STRYKER LOCAL SCHOOLS Ag Ed Addition and Courtyard Infill Stryker, Ohio

C0-4681

ADDENDUM 2

ITEM NO. 11: <u>Sheet E-121 – Courtyard Infill Lighting, Communications</u> <u>& Fire Alarm Plans, Light Fixture Schedule and Elevator Pit Plan</u>

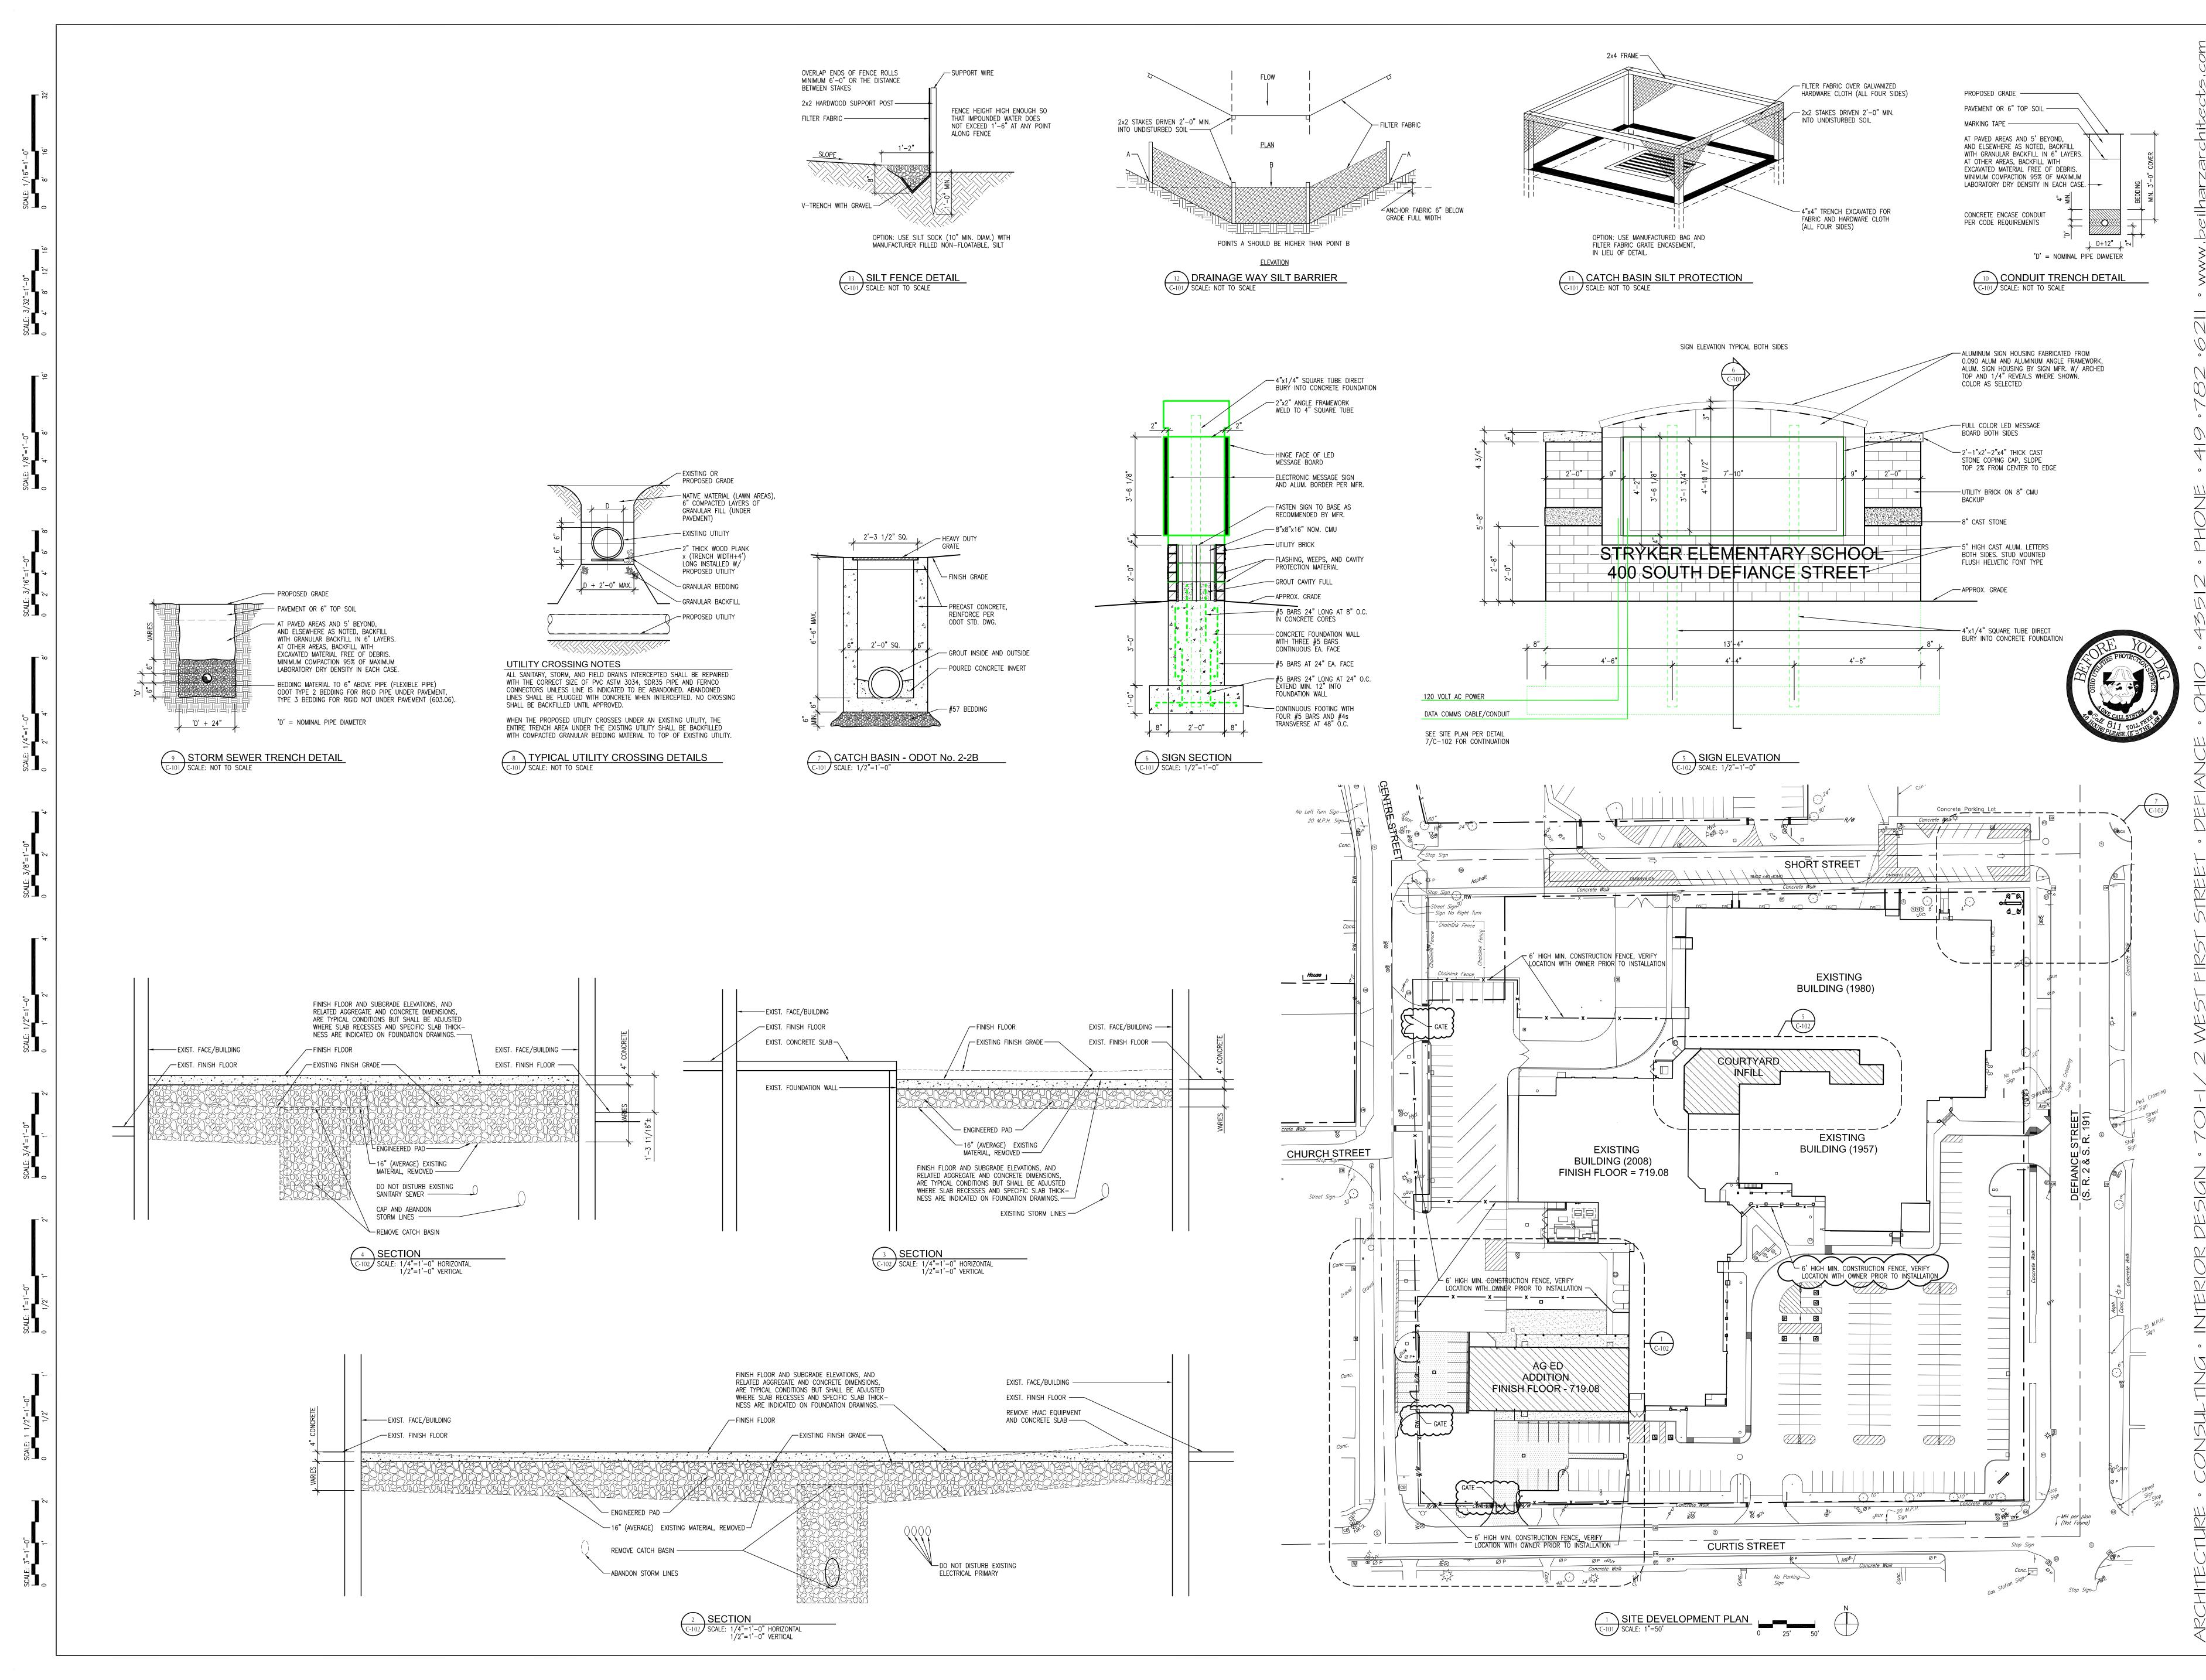
Courtyard Infill First Floor Lighting Plan 1: Add Keynote 6 for new cameras in southwest corner of Fine Arts Classroom C104 and on southwest angled wall of Event Team Room C111.

Light Fixture Schedule:

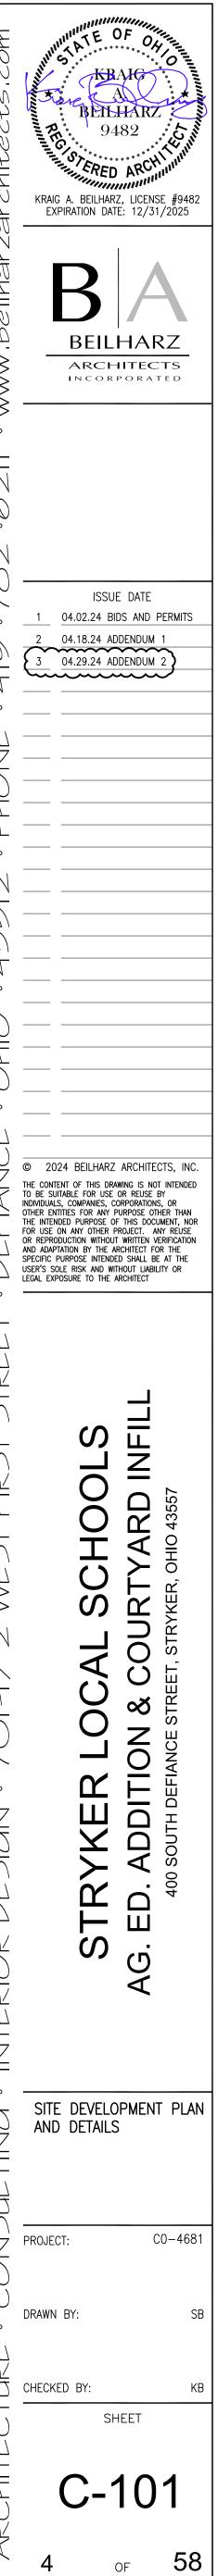
- 1. B1EM, B2EM, B3EM, B4EM, C1EM: Delete emergency battery packs. Provide generator transfer device integrated with fixture, or an external switch bypass device, to override local switching and connect to emergency power on loss of normal power.
- 2. C2: Revise model number to FEM L96 12000LM IMAFD WD 35K 80CRI.
- 3. E1: Delete note for remote exterior head.
- 4. W2 wall sconce shall have 10'-0" mounting height to center.
- 5. W3 wall sconce shall have 18'-0" mounting height to center.
